PROJECT INFORMATION

ADDRESS: 1002 WEST LAKE SAMMAMISH PKWY NE
BELLEVUE, WA 98008

PROJECT DESCRIPTION: TO RENOVATE AN EXISTING 2 STORY HOME, ADDING A 3RD LEVEL AND GARAGE. PROJECT WILL INCLUDE PAVER AND GRASS RE-SEEDING AND WILL NEED TO FOLLOW BEST MANAGEMENT PRACTICES FOR SHORELINE PROPERTIES. DECONSTRUCTION PROCESS TO LOOK AT RESPONSIBLE WAYS TO RECYCLE/REDUCE WASTE FOR COST SAVING OPPORTUNITIES

SITE PLAN

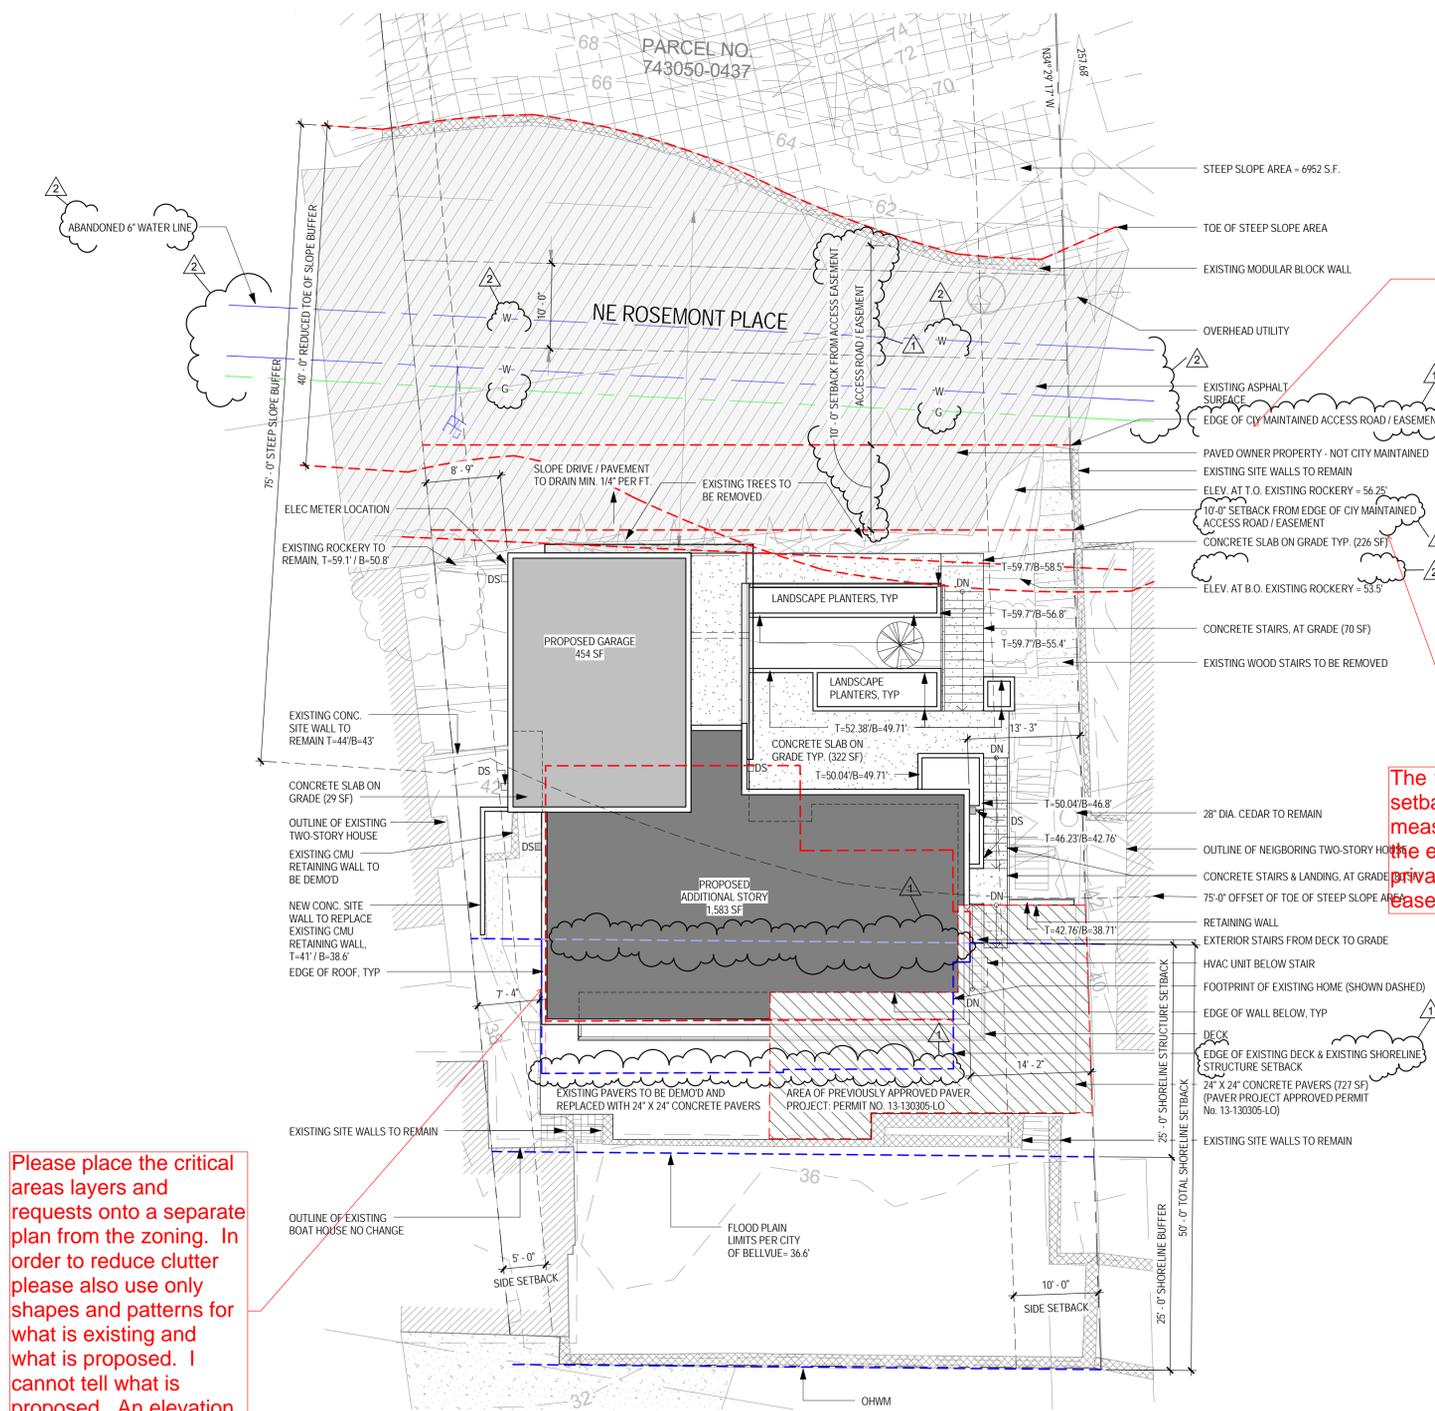
Revise the plan or provide a separate plan to clearly show the existing structure, required setback boundaries, and any expansions into those setbacks through use of hashing, color or some other means. Also callout the square footage of the expansion into any protected setbacks. Any temporary disturbance for construction must also be shown with the area calculated.

Please remove all references on all plans to "City maintained" road as the City does not maintain this private road. There is 40-foot private road easement over the property. If there is some legal documentation available on the easement please provide it.

Please place the critical areas layers and requests onto a separate plan from the zoning. In order to reduce clutter please also use only shapes and patterns for what is existing and what is proposed. I cannot tell what is proposed. An elevation view is also recommended.
